MONTICELLO NUCLEAR GENERATING PLANT

REQUEST FOR AMENDMENT TO  
OPERATING LICENSE DPR-22

LICENSE AMENDMENT REQUEST DATED FEBRUARY 18, 1987

Exhibit A

FIGURE 1 Electrical Contacts for the IRM/APRM Scram Circuitry

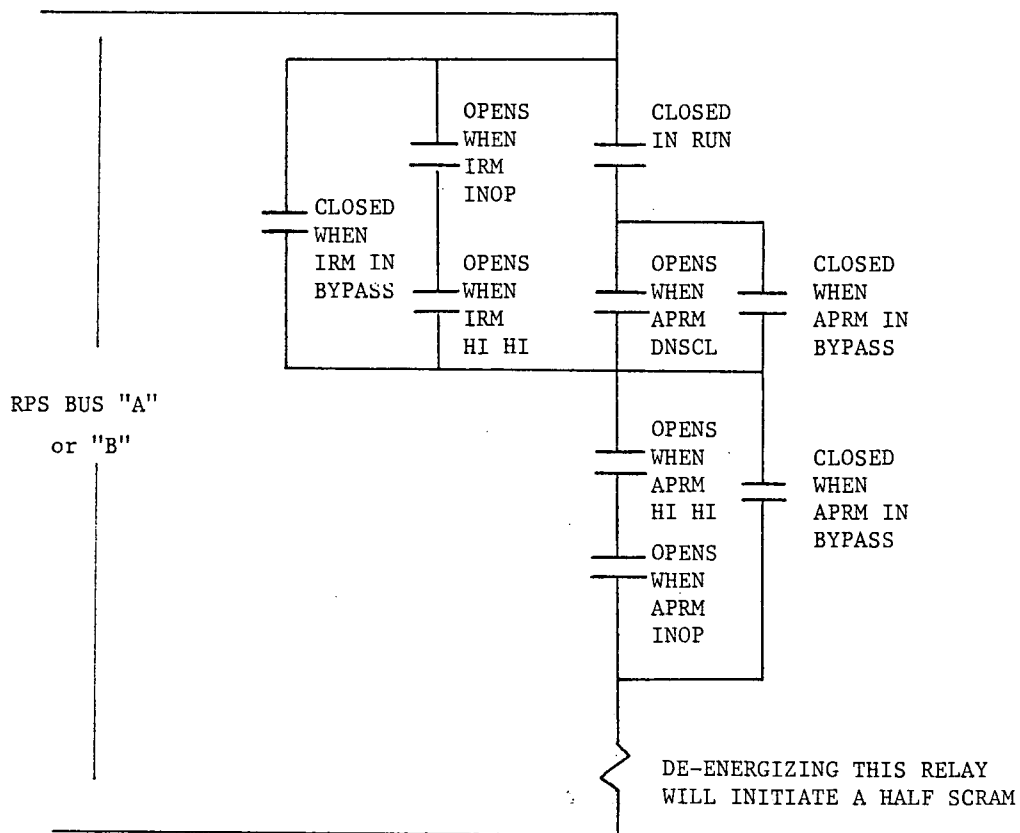
The first problem involves the requirement for an APRM downscale scram. The APRM downscale scram is actually not a scram but a bypass of the IRM scram trips when in the Run Mode. The circuitry involved is shown in Figure 1. In the Run Mode at power, the IRM HI HI contacts are closed (since the detectors are withdrawn from the core) as are the IRM INOP contacts. Therefore, if the associated APRM channel goes downscale (less than 3/125 of full scale) no scram would occur. The purpose of the APRM downscale contact is to bypass the IRM scram trips when in the Run Mode and the APRM is reading above 3/125 of full scale. The wording of the current Technical Specifications implies an APRM downscale should cause a half scram. The circuitry and the Technical Specification wording has not changed since the initial plant startup.

When an APRM is bypassed the associated IRM is also bypassed (See Figure 1). This note requires the associated APRM to be operable in order to bypass an IRM. Since a bypassed APRM cannot be considered operable, one could consider an IRM to be inoperable when the associated APRM is bypassed. Since the minimum number of IRM channels is 3 of 4 per trip system, no problem exists except when APRM #3 or #4 is bypassed. APRM #3 or #4 each have two IRMs associated with them (See Figure 2). Bypassing APRM #3 bypasses IRMs #13 and #14. Bypassing APRM #4 bypasses IRMs #15 and #18. Using the same logic mentioned above, the minimum number of Operable channels could not be met whenever APRM #3 or #4 are bypassed. This note could be used to require operability of the IRMs when any APRM is bypassed. This is clearly not the intent of this specification, since there is no need for the IRMs to be operable in the Run Mode when 2 of the 3 APRM channels are operable. Therefore, we propose to delete Note c of Table 3.1.1 and clarify the associated bases. This change is proposed only to clarify the Technical Specification. No change has been made to the associated electrical circuitry since initial plant startup.

Change Table 3.1.1 by eliminating IRM operability in the Run mode and deleting the APRM downscale scram (page 28). Change Note 2 (page 29) to read:

Delete Note c on Table 3.1.1 (page 30)
